**TOWN OF MOUNTAIN VILLAGE
REGULAR DESIGN REVIEW BOARD MEETING AGENDA
THURSDAY MAY 2, 2024, 10:00 AM
MOUNTAIN VILLAGE TOWN HALL
455 MOUNTAIN VILLAGE BLVD, MOUNTAIN VILLAGE, COLORADO
TO BE HELD HYBRID THROUGH ZOOM:
<https://us06web.zoom.us/j/89545752025>
Meeting ID: 895 4575 2025**

TO: Mountain Village Design Review Board
FROM: Claire Perez, Planner II
FOR: Design Review Board Meeting; May 2, 2024
DATE: April 22, 2024
RE: Staff Memo – Initial Architecture and Site Review (IASR) Lot 205A, 112 Stevens Drive.

LOT 205A - ADDITION/RENOVATION RESIDENCE
 LOT 205A, 112 STEVENS WAY, MOUNTAIN VILLAGE, CO.

PROJECT NAME:
SINGLE FAMILY
LOT 10, STONEGATE
MOUNTAIN VILLAGE, CO

Figure 2: South Elevation

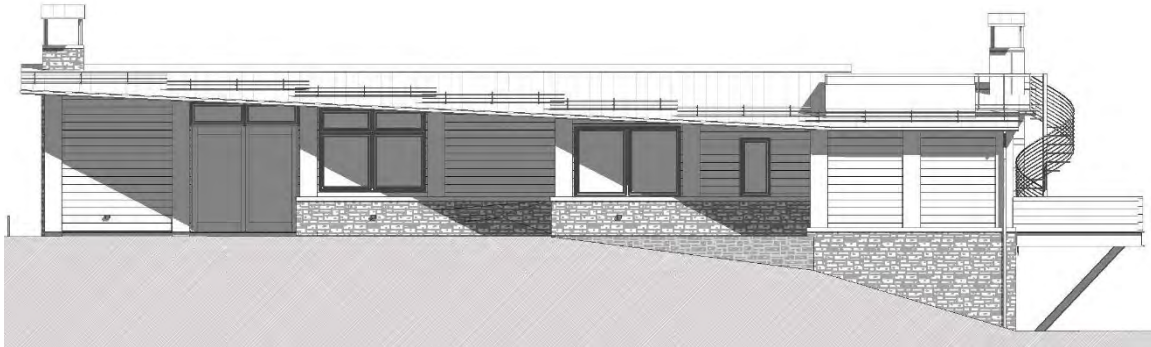
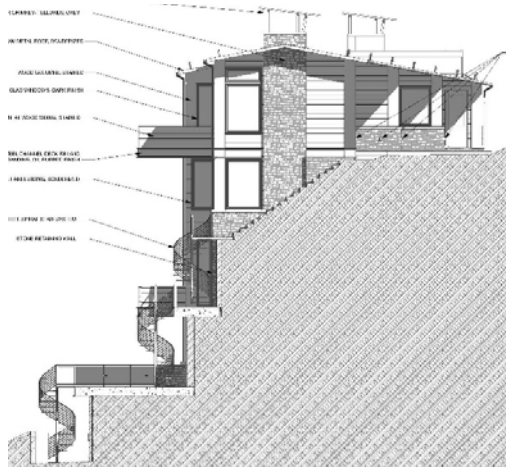
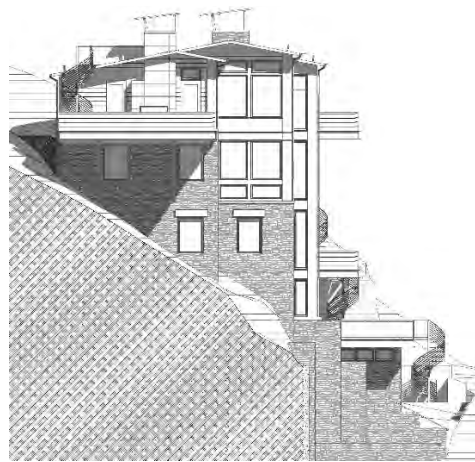
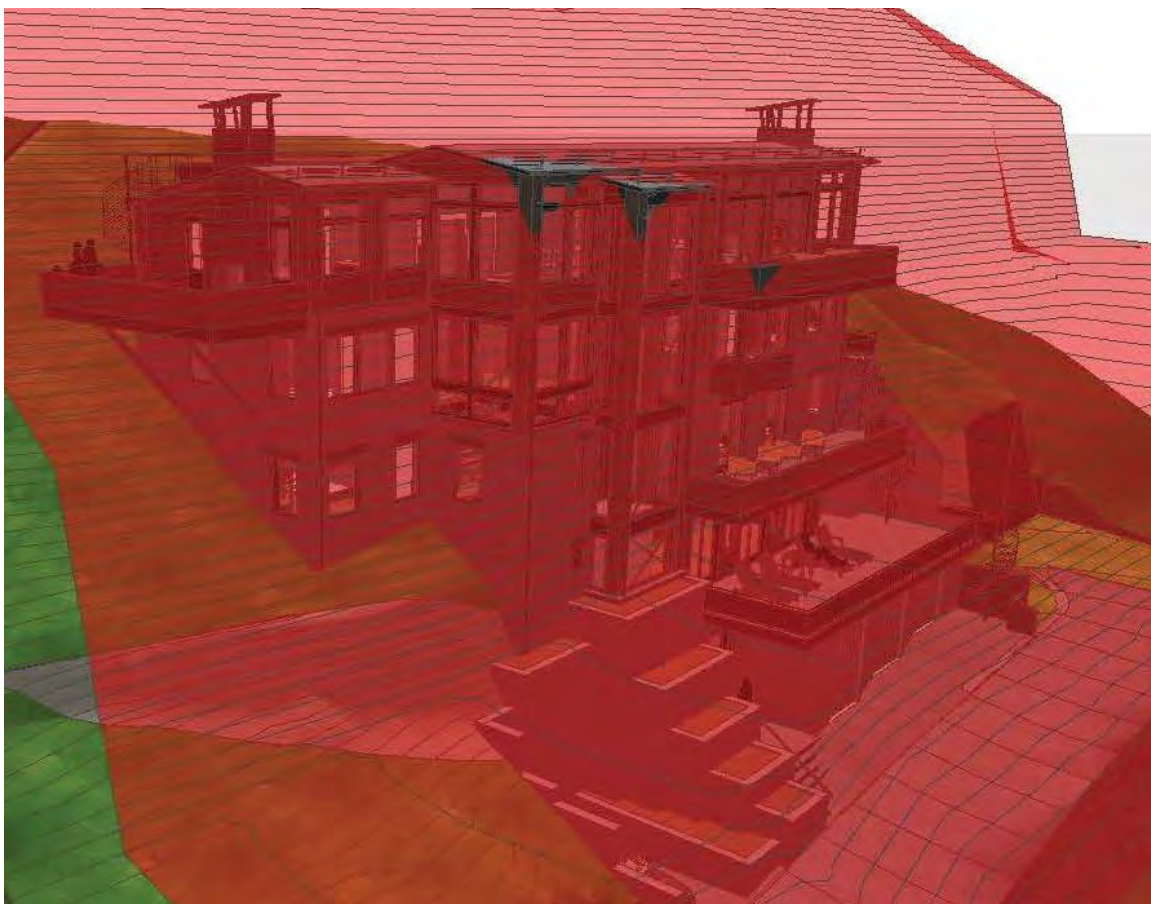
Staff: The primary roof form of the proposed structure is gabled and is therefore granted a maximum height of 40 feet and an average height of 35 feet. The applicant has indicated that the maximum height of the current proposed structure is 45.17 feet and has an average height of 28.46 feet (Sheet A-009 of the attached plan set). The CDC requires that height is demonstrated relative to both existing and proposed grade and that the most restrictive measurements be used to determine height. The applicant has not provided any information on heights as it relates to the proposed grade. The applicant should revise the drawings to demonstrate both existing and proposed grade for each height so staff can determine whether the true maximum and average height is being shown accurately.

Due to the extreme slope of the site (with slopes over 50% for much of the site), the applicant is requesting a variance to the maximum height of 5.17 feet over the allowable limits. The area of impact for the variance is limited to the main gable roof and the elevator shaft. The height variance is desired to allow for an habitable structure that fits the Mountain Village building vernacular, as the steep natural grade of the site and the no-build zone on the west side of the property limit the size of the building footprint and therefore the size of an individual story.

Figure 7: Site Plan – Proposed Parking

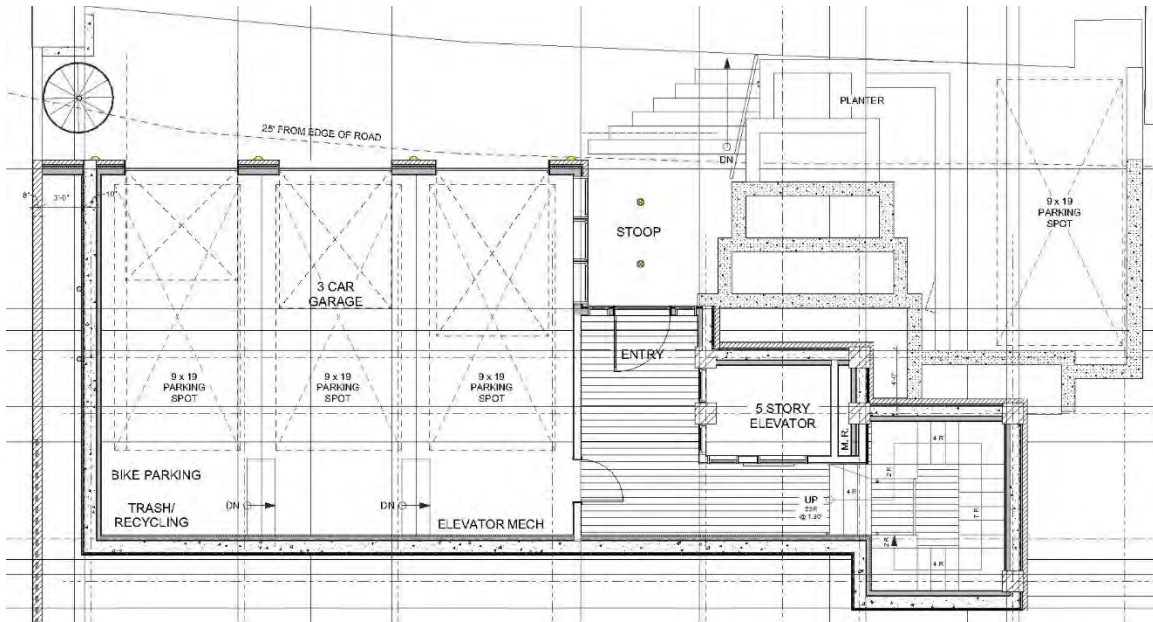
The parking regulations (Section 17.5.8.C.2.) requires that garages that are designed to have cars backing out shall have a minimum of 25' of backup space for vehicles exiting a garage. Due to the unique nature of the site, the minimum space cannot be provided for the exterior space. In addition, due to the extremely narrow profile of the existing shared access drive, it is recommended that the applicant demonstrate turning movements into and out of the garage and to evaluate whether access to the garages is feasible.

Staff: As noted previously, the CDC requires at least 25' of backing space for garages that back out onto the road. This distance cannot be provided for the exterior space due to the unique nature of the site as well as Stonegate Drive/shared access bisecting the lot. Stonegate Drive and the shared driveway access is quite steep and narrow in this location. Prior to Final Architecture Review, the applicant should provide turning movement calculations to show that vehicles can safely enter and exit from the shared access drive into and out of the garages, and may need to look at widening the access to accommodate turning movements.

- 3) *Prior to final review, the applicant shall provide turning movement diagrams that demonstrate the feasibility of vehicles entering and exiting the garage spaces from Stonegate Drive.*

Figure 8: Landscape Plan

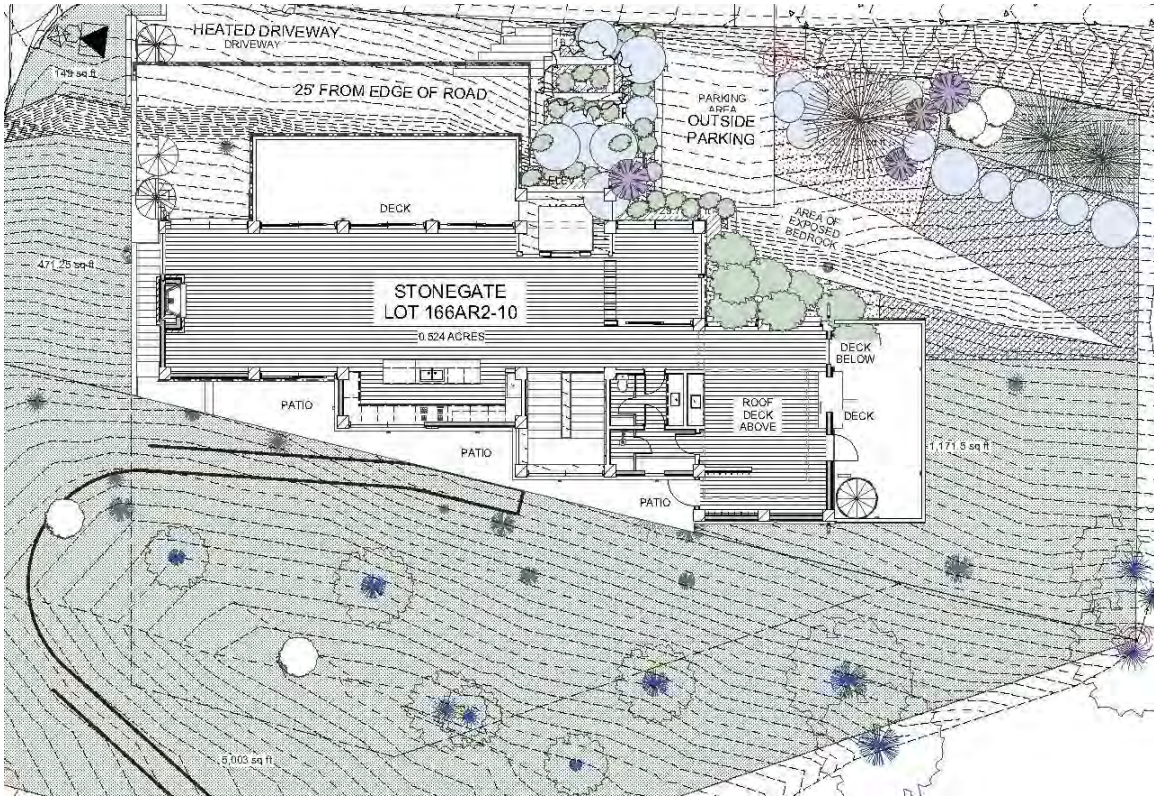
“The tree that is planned to be installed on the north corner of the home at the bottom of the stairs (Sheet A-004) is located too close to the side of the home and is not recommended by the Town of Mountain Village (current wildfire best management practices state that no vegetation should be installed within 5 feet of the edge of the home (the drip edge of vegetation should be a minimum of 5 feet from the edge of the home).”

“The tree and shrubs planned to be installed right up against or under the south deck of the home are located too close to the deck. According to the CDC, trees must be clear of the home at a minimum distance of 15 feet from the outside edge of the dripline of the building, which includes decks, planters, and patios (with some very specific exceptions, which are not indicated on the Landscape Plan, Sheet A-004). In the event of a wildfire, deck areas are highly vulnerable because they trap swirls of super-heated turbulent currents of air underneath the deck and this is often a location for home ignition. Vegetation and other flammable materials underneath and near decks greatly contribute to this condition.”

All recommendations of the Town Forester should be incorporated into the landscape plan prior to Final Architectural Review.

- 4) *Prior to final review, the applicant shall provide an updated landscape and fire mitigation plan showing compliance with the Fire Mitigation standards and the Town Forester's comments.*
